RECALL BULLETIN:
190412REV

MODEL(S) AFFECTED:
32 S Only

Inspection / Correction of Generator Exhaust Pipe Routing

May 2019

Figure 1 – Correct Installation

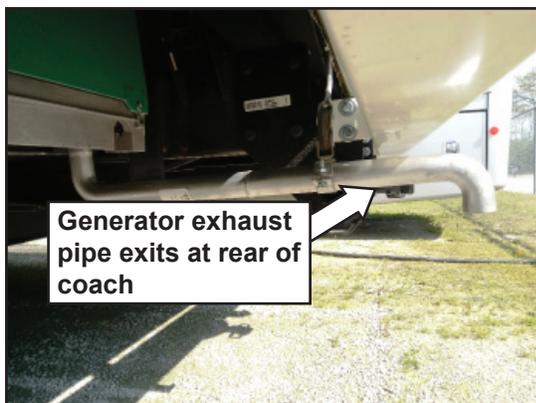
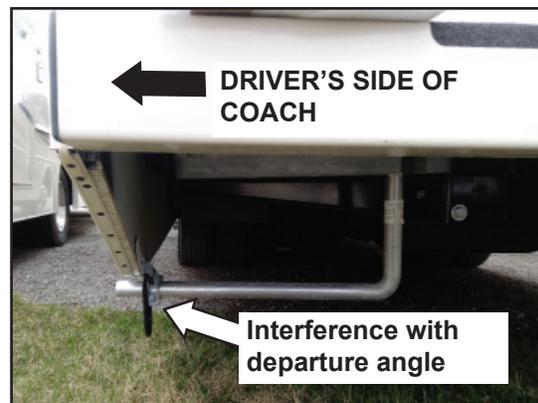
3. Block wheels to prevent movement.
4. At the driver's side, rear of the coach, locate the generator exhaust pipe and determine whether it exits on the side of the motorhome or out the rear, under the bumper. See Figures 1 & 2 for both examples of exhaust pipe routing.

Figure 2 - Repair Needed

- a) If the generator exhaust pipe exits the motorhome at the rear of the coach under the bumper, take several clear photos (see Photo Requirements on Page 3) and submit a claim using code 6080-11, "Inspected/Not Defective"; no more work is required.

- b) If the generator exhaust pipe exits on the side of the motorhome, take several clear photos (see Photo Requirements on Page 3) and then proceed to the Repair Procedure beginning at Step 5.

Figure 3

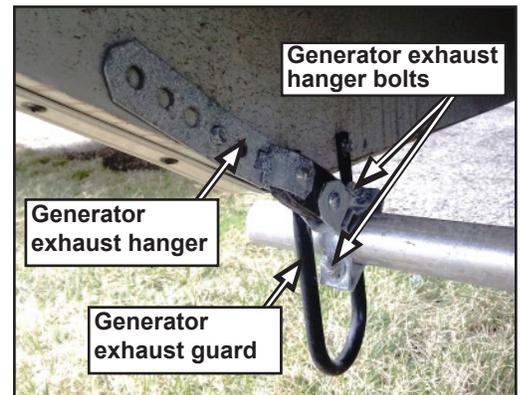
5. Referencing Figure 3:

- Remove the hardware clamping the generator exhaust hanger to the generator exhaust pipe using a $\frac{1}{2}$ ” open end wrench and ratchet with a $\frac{1}{2}$ ” deep well socket.
- Once loose from the exhaust pipe, remove the generator exhaust hanger by removing the $\frac{1}{4}$ ” HWH screw holding it to the sidewall with a $\frac{3}{8}$ ” driver bit and drill. Set aside all of the generator exhaust hanger components and fasteners for later reinstallation.
- Using a $\frac{3}{8}$ ” driver bit and drill, remove both $\frac{1}{4}$ ” HWH screws holding the generator exhaust pipe guard to the sidewall. Discard the generator exhaust pipe guard and mounting screws as they will not be reinstalled.

Figure 4

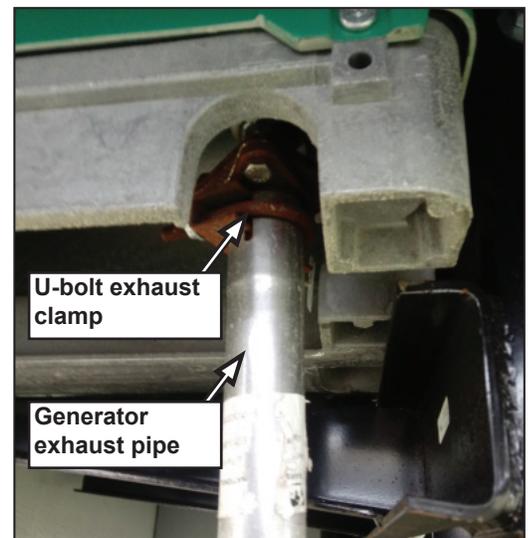
6. Referencing Figure 4, remove the generator exhaust pipe by loosening the U-bolt clamp securing the generator exhaust pipe to the generator with a ratchet and a $\frac{1}{2}$ ” deep well socket. Set aside the U-bolt exhaust clamp for later reinstallation. Discard the generator exhaust pipe as it will not be reinstalled.

Figure 5

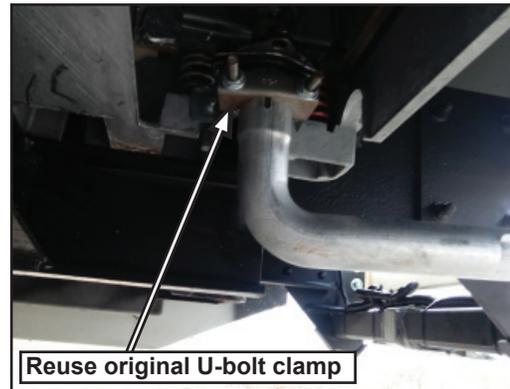
7. Begin reinstallation by sliding the new generator exhaust pipe onto the generator exhaust port until it is fully seated to the bottom of the flared end or is tight against the bottom of the generator. Be sure it is oriented so that it exits the rear of the vehicle under the bumper; reference Figures 5 and 6. Clamp in place with the U-bolt exhaust clamp previously removed in Step 6; carefully position the U-bolt so that the nuts can be easily tightened with a ratchet and a 1/2" deep well socket.

Figure 7

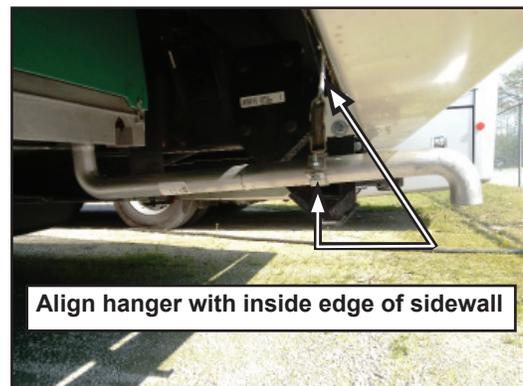
9. Use silicone sealant to seal the screw holes in the sidewall where the defective components were removed, in order to prevent water intrusion.
